Authorized Field Change

AFC 17901

Subject: CE Bus Air Door with Steering Wheel Switch

Model: CE Bus

Figure 4. DLB Features Tab

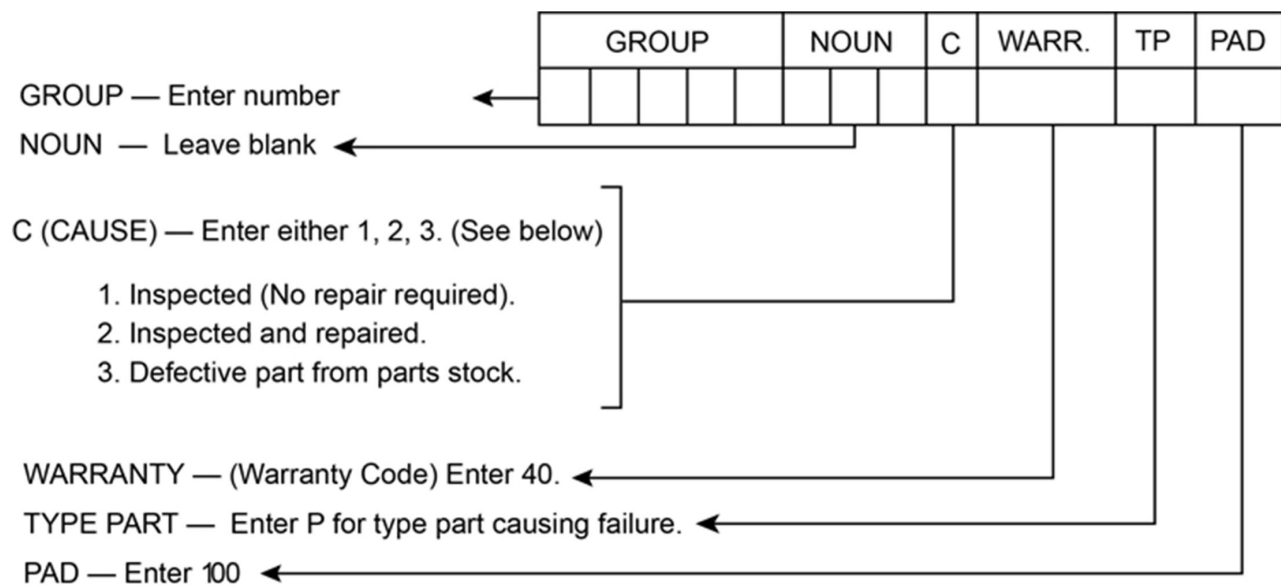
12. Select the FEATURES tab (Figure 4, Item 1).
13. If Installed box is checked for feature 0595AGH (Figure 4, Item 4), uninstall and replace this feature:
 - a. Uncheck INSTALLED box for FEATURE 0595AGH.
 - b. Check INSTALLED box for FEATURE 0595BDA.
14. If INSTALLED box is checked for FEATURE 0595AGE (Figure 4, Item 3), uninstall and replace this feature:
 - a. Uncheck INSTALLED box for FEATURE 0595AGE.
 - b. Check INSTALLED box for FEATURE 0595BCZ.
15. Click PROGRAM icon (Figure 4, Item 2).
16. Wait for status bar at the bottom of the window to indicate that the system is resetting.
17. Switch parking lights OFF.
18. Disconnect EZ-Tech® or EST from vehicle.
19. Remove wheel chocks.
